City of Phoenix PLANNING AND DEVELOPMENT DEPARTMENT

Staff Report Z-13-20-8 December 30, 2020

Proposed Use: Removal of the TOD-1 zoning overlay

Location: Northwest corner of State Route 143 and Washington Street

Source: Bowman Consulting

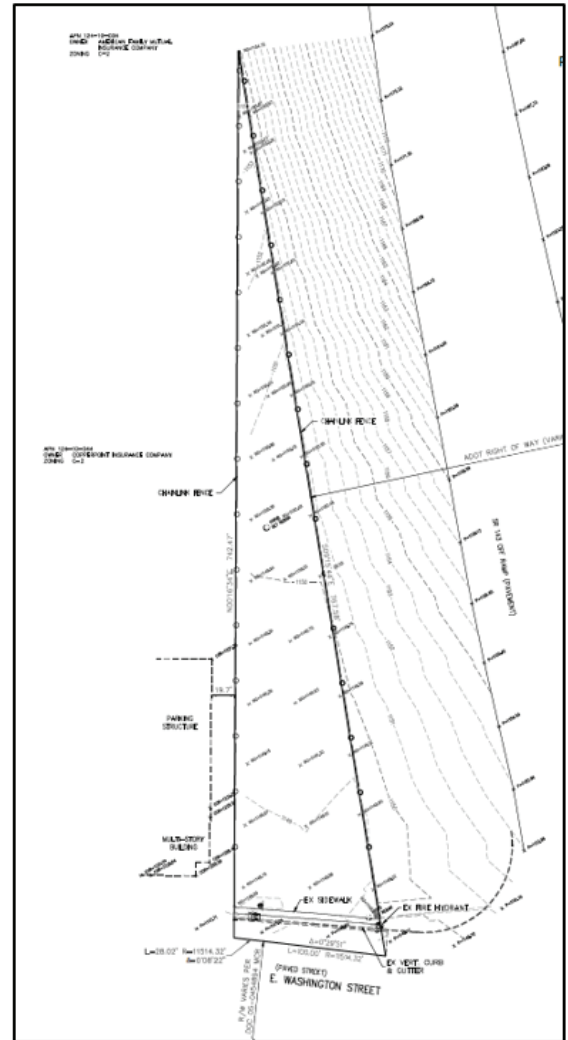
3. The proposed site plan does not depict any development on the site, nor does the project narrative call out a specific use for the property. The primary intent of this rezoning request, per the applicant's narrative, is to "allow the property owner to maximize the property's value."

Given the size and shape of this property, any proposed development under the A-2 development standards would likely require several variance requests through the Zoning Adjustment hearing process.

Further, there is no access to the site depicted on the site plan. With its proximity to the freeway off-ramp, the Arizona Department of Transportation has commented that it will not permit a new driveway to be constructed at this location.

Staff recommends denial of the request but does acknowledge that the site's location, dimensions and limited access points, are challenges for its development as standalone parcel. Removal of the Overlay will provide some flexibility for the property owner to pursue redevelopment options.
